REMARKS

SHIMIZU et al.
Serial No.: 09/722,664
Response to Office Action dated September 2, 2003

Fig. 11

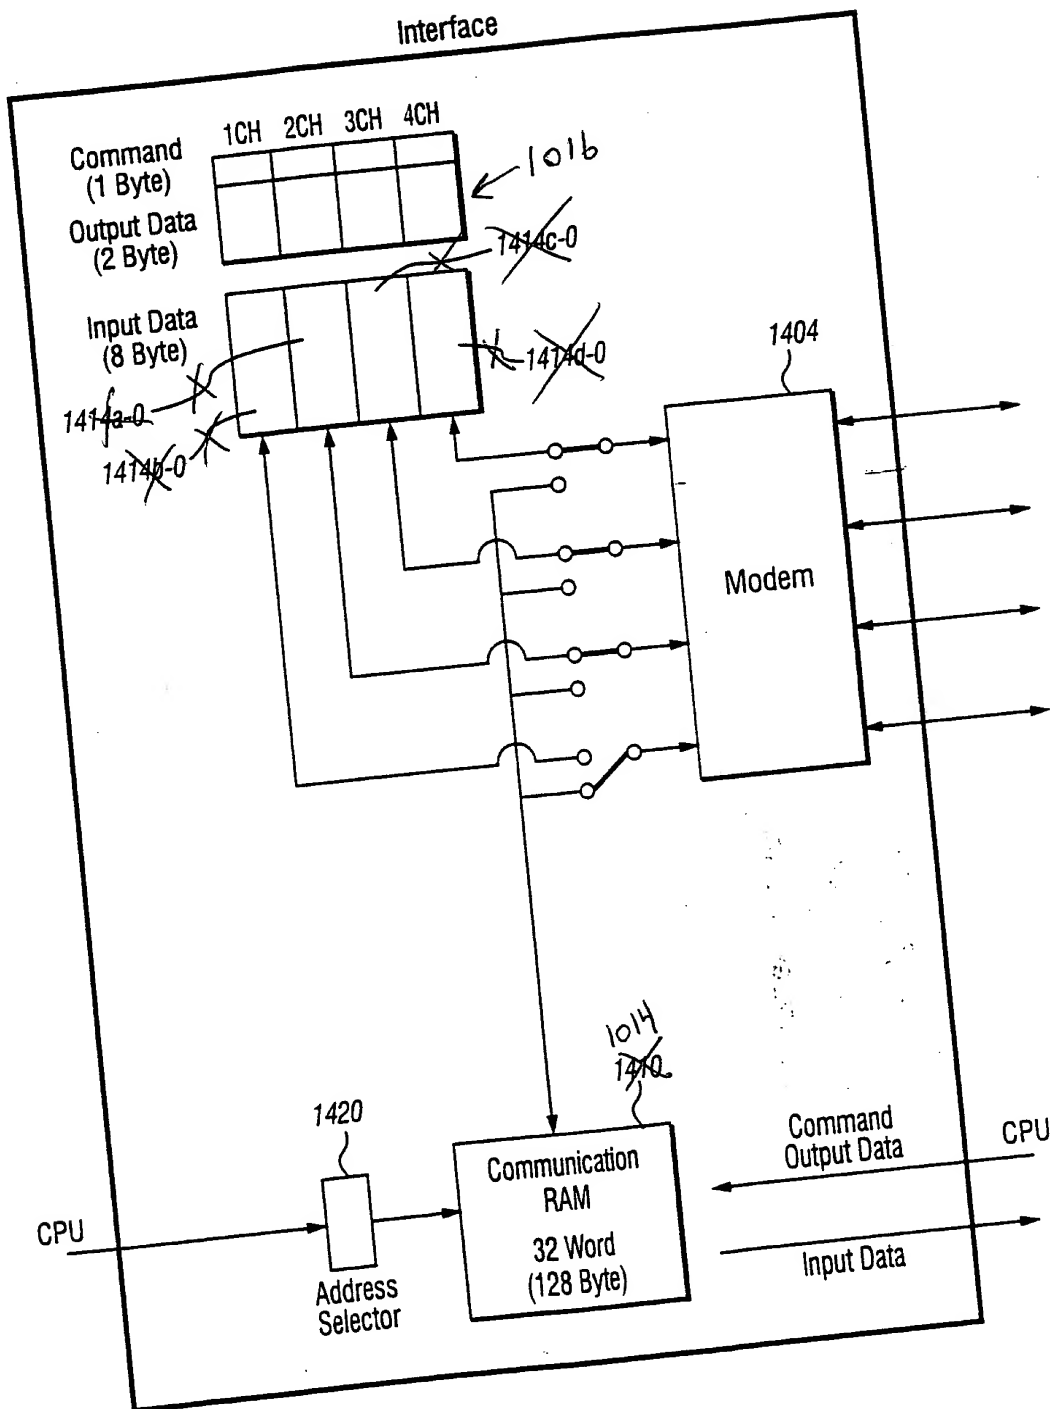
- changed the references in the specification to communication RAM 1410 to communication RAM 1014 and made a corresponding change to Figure 11; and
- changed the reference to input/output buffers 1414 at page 41, line 7 to input/output buffers 1016 and made a corresponding change to Figure 11.

Fig. 17

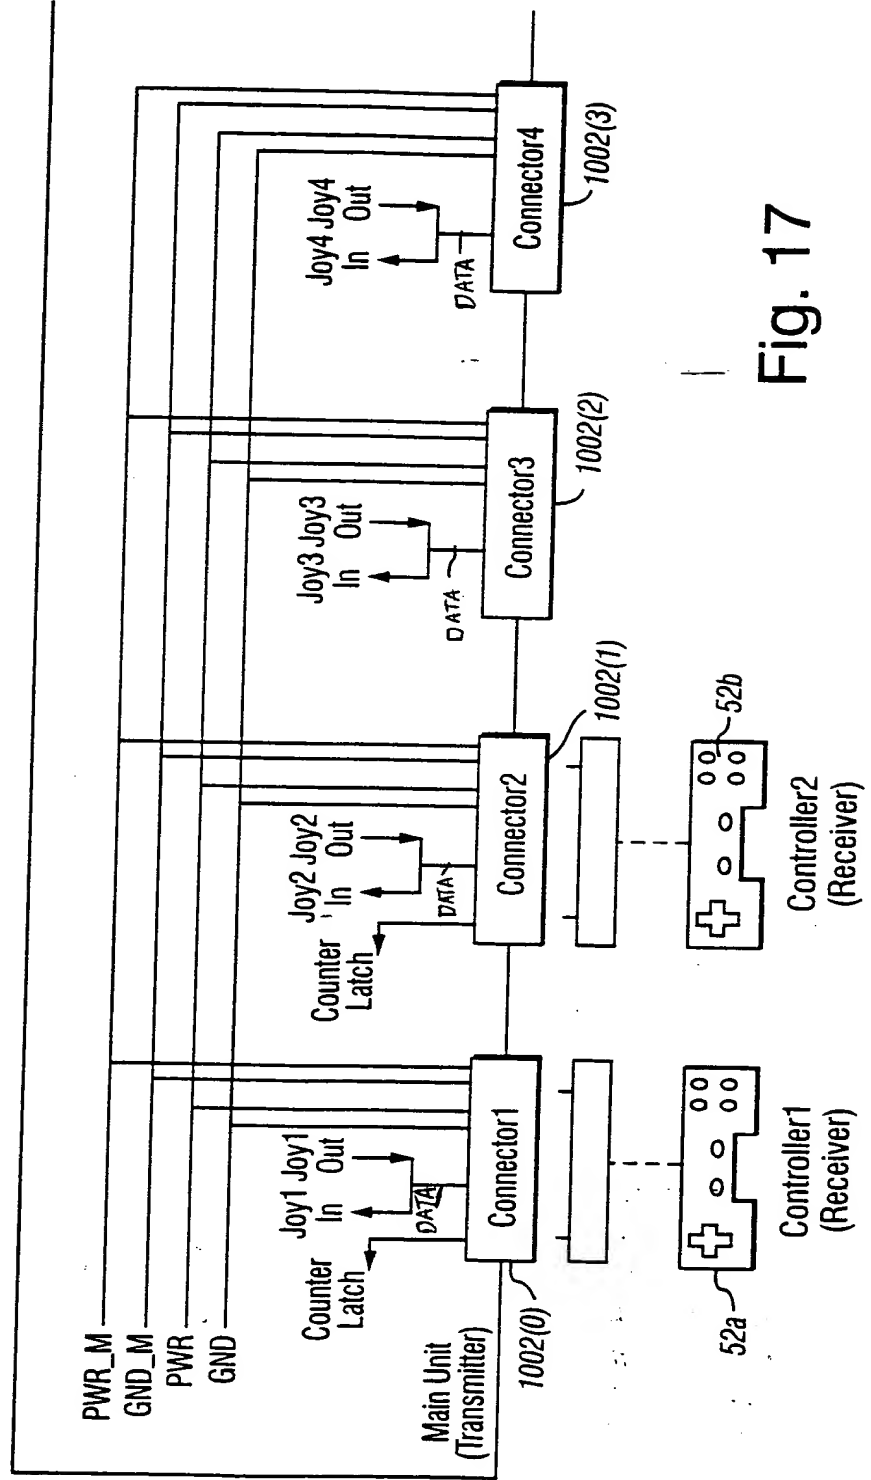
The drawings were objected to as failing to comply with 37 C.F.R. 1.84(p)(5). In response to this objection, Applicants have (1) designated the box labeled "Rasterize" in Figure 5 with the numeral "400b" as described, for example, at page 17, lines 6-9; and (2) identified the DATA lines in Figure 17 as described, for example, at page 45, lines 4-14. Based on these changes, withdrawal of the objection under 37 C.F.R. 1.84(p)(5) is respectfully requested.
